UNITED STATES PATENT AND TRADEMARK OFFICE

APPLICATION NO.	FILING DATE	FIRST NAMED INVENTOR	ATTORNEY DOCKET NO.	CONFIRMATION NO.
10/592,969	06/25/2008	Silvia Gerstner	2004P00358WOUS	4067

Office Action Summary	Application No. 10/592,969	Applicant(s) GERSTNER ET AL.	
	Examiner DANIEL ROHRHOFF	Art Unit 3637

DETAILED ACTION

Leimkuehler Fig. 4

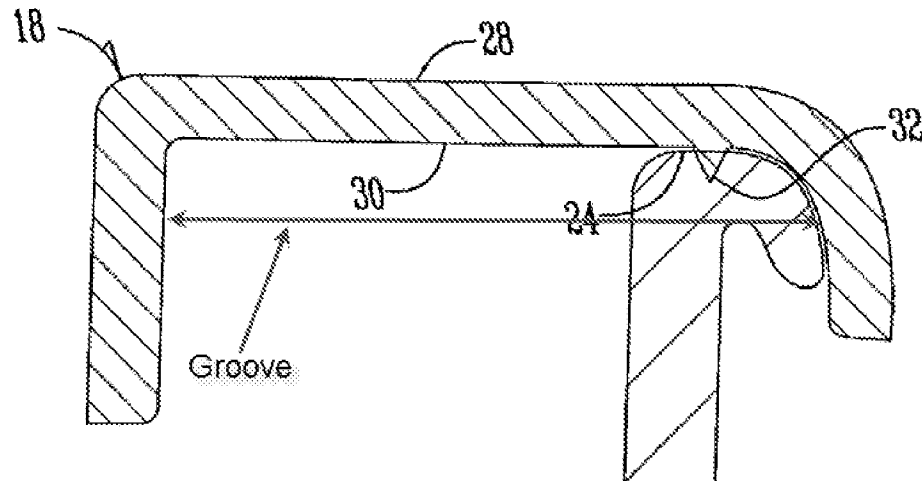
9. Regarding claim 20, Leimkuehler discloses a refrigerator comprising: an inner space (inside of 10) enclosed by a heat-insulating housing (walls of 10); at least one compartment (16) for accommodating articles to be cooled and being disposed within the inner space (Fig. 1) and having a curved edge (24); and a strip (18) disposed on a top of the curved edge (Figs. 2-4) and including a plastic core (§ 21) wherein the strip has a groove (see annotated Fig. 4) into which the edge of the compartment for accommodating articles to be cooled is inserted (Fig. 4).

12. Regarding claim 11, Leimkuehler, as modified, teaches a refrigerator wherein the strip has a groove (see annotated Fig. 4) into which the edge of the compartment for accommodating articles to be cooled is inserted (Fig. 4).
